Re: Taos Ski Valley Gondola and Other Improvements Project

These are comments on the proposal by Taos Ski Valley Inc. to build out new components to its existing resort in Taos County, New Mexico. The currently proposed projects present numerous issues that I feel must be addressed. I request that a full Environmental Impact Statement (EIS) be developed to address these concerns.

Figure 2. Relationship of wetlands to gondola site

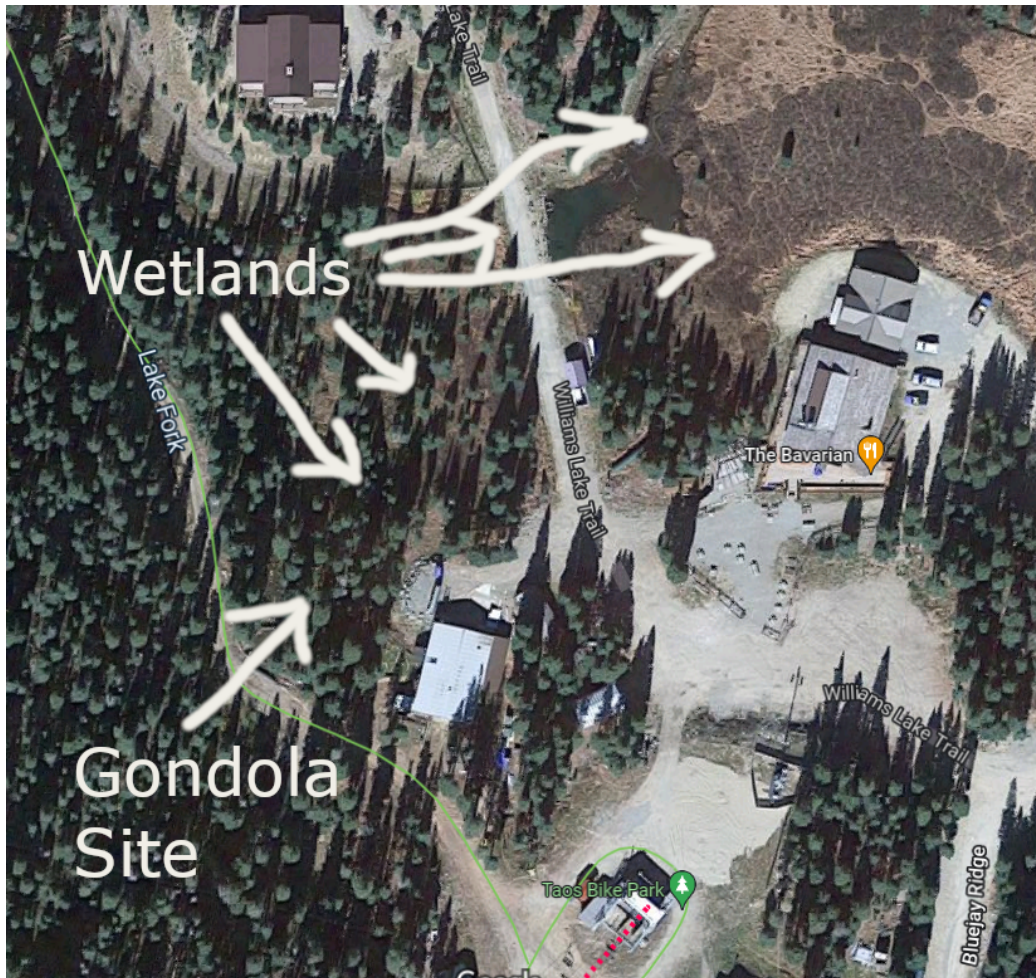
Based on the map distributed with the Notice and the limited description in the text of the Notice, TSV Inc. is proposing to build a Bridge/Terminal/Maintenance Complex in a riparian area and either on or immediately adjacent to a wetland. The "small stream" to be bridged and built on, is an important part of the Rio Hondo system and has an associated riparian environment. It not only adds its waters to the Lake Fork of the Rio Hondo but is a prime reason wetlands exist in the area.

Those wetlands are a unique and important part of the forest environment in the Kachina basin. Just like the rest of the Rio Hondo system, the wetlands support an amazing variety of animals and contribute to the ecological diversity of the area. The wetlands have already been disturbed by the construction of a road through their midst and the placement of the Bavarian restaurant. Further constraining the stream and wetlands with a bridge and building foundations for the gondola facility may diminish riparian habitat and the wetlands.

Locating the proposed gondola maintenance facility in the Lake Fork riparian area and on, or near, the wetland creates an unacceptable level of risk for contamination by the products to be used to maintain the gondola. Building the maintenance facility as proposed would likely violate Section V. B., Water Pollution, of the Ski Area Term Special Use Permit issued 6/5/2014 which reads, in part, "Storage facilities for materials capable of causing water pollution, if accidentally discharged, shall be located so as to prevent any spillage into waters or channels leading into water that would result in harm to fish and wildlife or to human water supplies." It would also conflict with the Riparian Management Zone Guidelines (FW-WSW-RMZ-G) of the Forest Management Plan: "To protect water quality and aquatic species, refueling, maintaining equipment, and storing fuels or other toxicants should not occur in riparian management zones"

Action Requested: I ask that the Carson National Forest (CNF) study the direct, indirect and cumulative effects of the gondola development on the fragile Kachina Basin riparian and wetland environments under each of the scenarios in the Draft EIS.
